Delegated Report	t	Analysis sheet		Expiry Date:	13/02/2025		
		N/A / attache	ed	Consultation Expiry Date:	20/01/2025		
Officer			Applicatio	n Number(s)			
Henry Yeung		2024/5687/P					
Annicotion Addu			Duran in a N	In the latest the late	1		
Application Addr 35 Meadowbank	ess		Drawing N	lumbers			
London Camden NW3 3AY			Refer to Draft Decision Notice				
PO 3/4 Are	a Team Sigr	nature C&UD	Authorised Officer Signature				
Proposal(s)							
Erection of an add terrace with a glas		above the existing	roof level of th	ne dwellinghouse, incl	luding a roof		
Recommendation	n(s): Refus	sal					
Application Type	: Hous	eholder Application	on

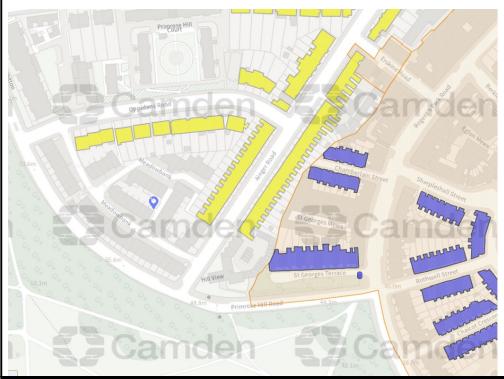
Loss of Light & Non-Compliance with Guidance:									
	The proposed 12.1m height at a 6m distance fails the 25-degree test for overshadowing, yet the application does not include an assessment in line with Camden Planning Guidance (2021). The design does not respect the established continuity of the terrace, disrupting any potential for a harmonious roofline.									
	The proposed development will be located 17m away from no.28 Ainger

Road, as the proposed development at the third level and encroaches on the 25-degree line of a habitable window of no.28 Ainger Road and it could potentially result in a loss of sunlight and increased overshadowing. The applicant failed to submit a daylight and sunlight assessment, to demonstrate that there would be a breach against BRE Guidelines and hence a noticeable impact to neighbouring daylight and sunlight

Comparatively, The development is located 9.3m away from No. 52 and No. 46 Meadow Bank, and will not have any impact on these properties.
